Addendum 153 – UN Regulation No. 154

Revision 1 – Amendment 1

Supplement 1 to the 01 series of amendments – Date of entry into force: 30 September 2021

Uniform provisions concerning the approval of light duty passenger and commercial vehicles with regards to criteria emissions, emissions of carbon dioxide and fuel consumption and/or the measurement of electric energy consumption and electric range (WLTP)

"Figure 8/1

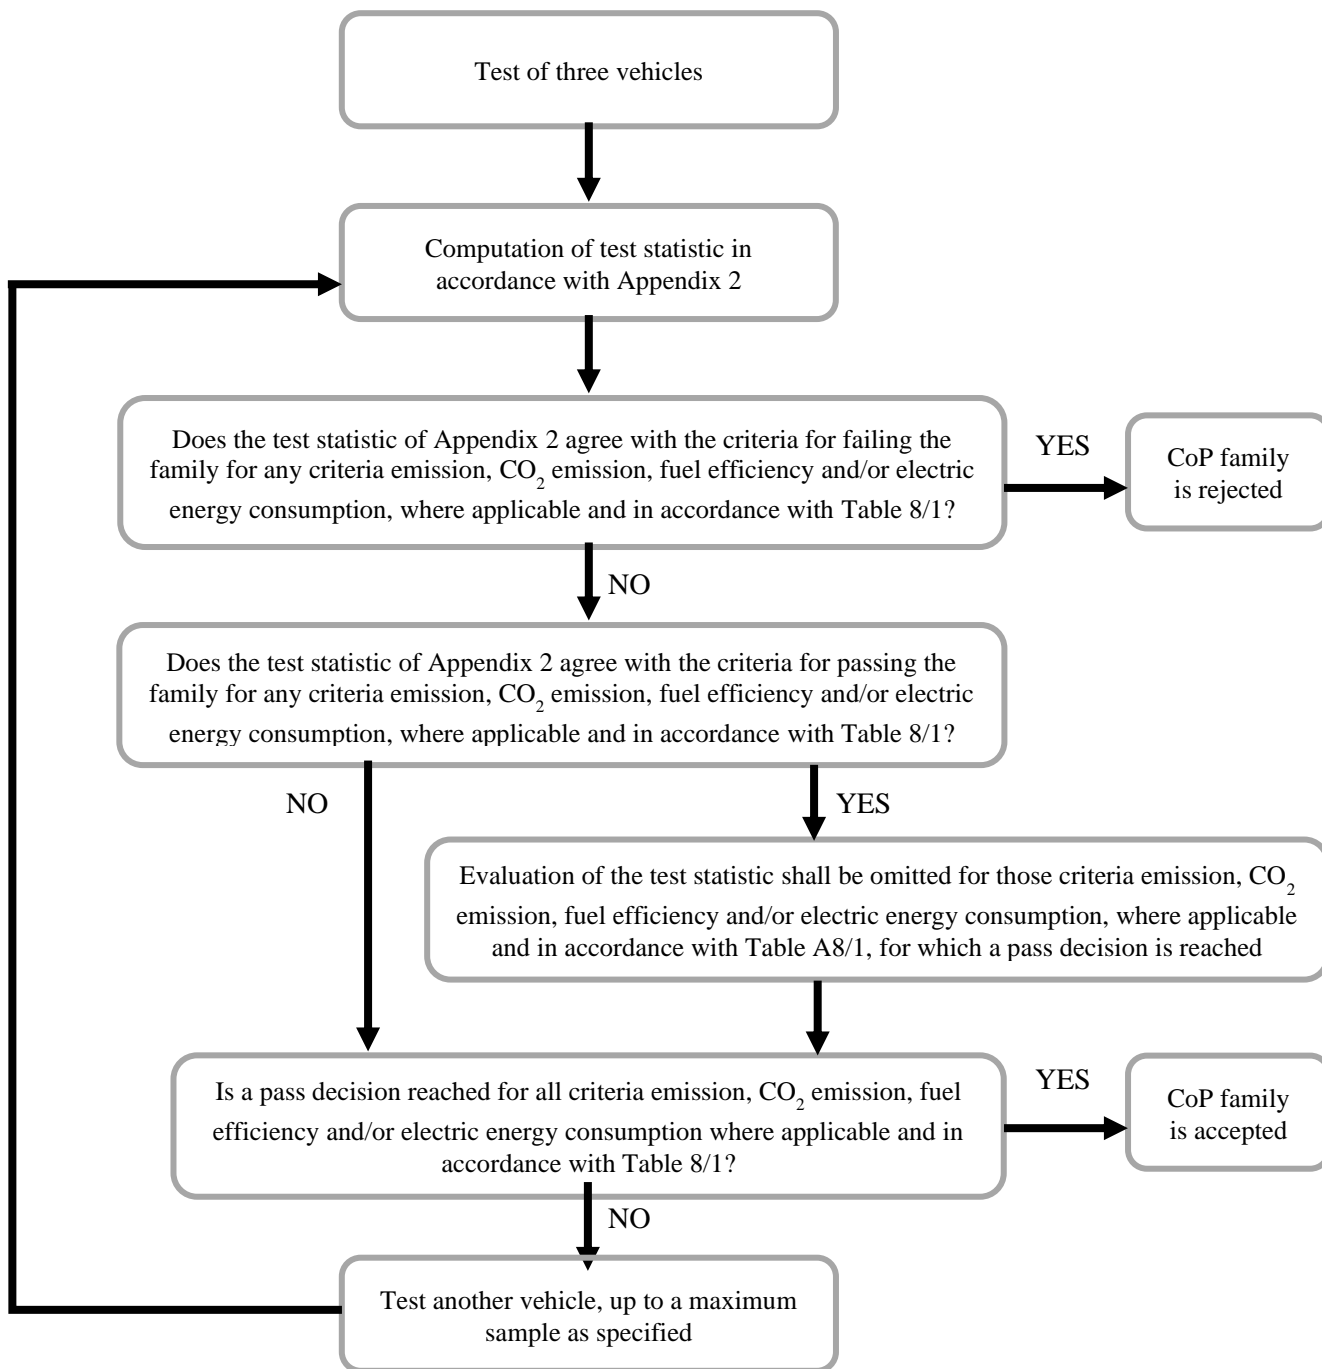
Paragraph 8.2.3.2., Figure 8/1, amend to read:

Flowchart of the CoP test procedure for the Type 1 test

Figure A6/4

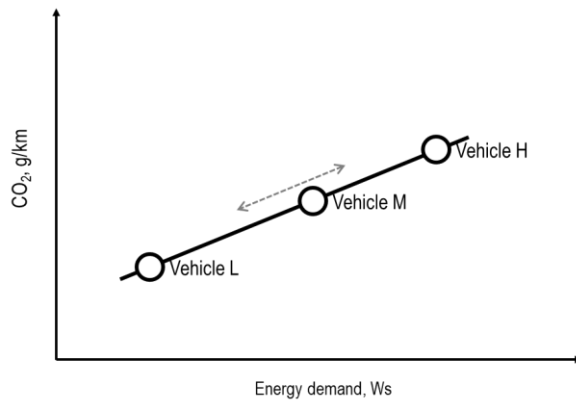
Paragraph 2.3.2.4., amend to read:

"2.3.2.4. Vehicle M is a vehicle within the interpolation family between the vehicles L and H with a cycle energy demand which is preferably closest to the average of vehicles L and H.

The limits of the selection of vehicle M (see Figure A6/4) are such that neither the difference in CO₂ emission values between vehicles H and M nor the difference in CO₂ emission values between vehicles M and L is greater than the allowed CO₂ range in accordance with paragraph 2.3.2.2. of this annex. The defined road load coefficients and the defined test mass shall be recorded.

Figure A8/2

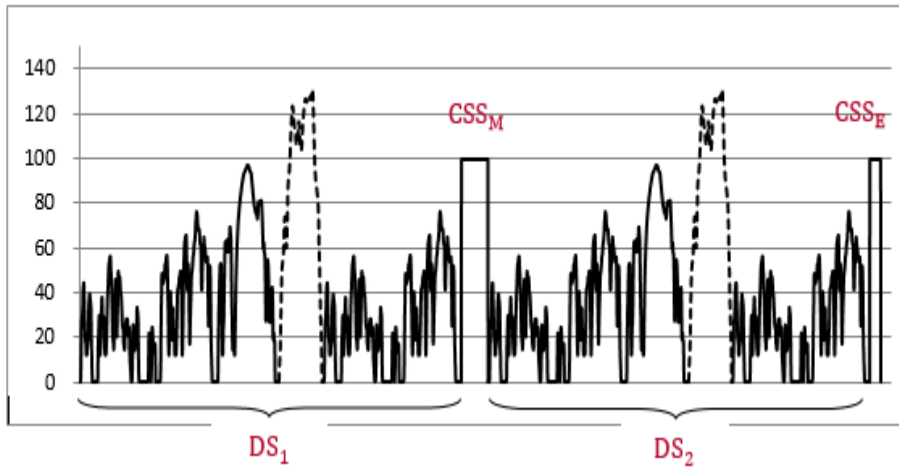
Paragraph 3.4.4.2.1., amend to read:

"3.4.4.2.1. Speed trace

The shortened Type 1 test procedure consists of two dynamic segments (DS₁ and DS₂) combined with two constant speed segments (CSS_M and CSS_E) as shown in Figure A8/2.
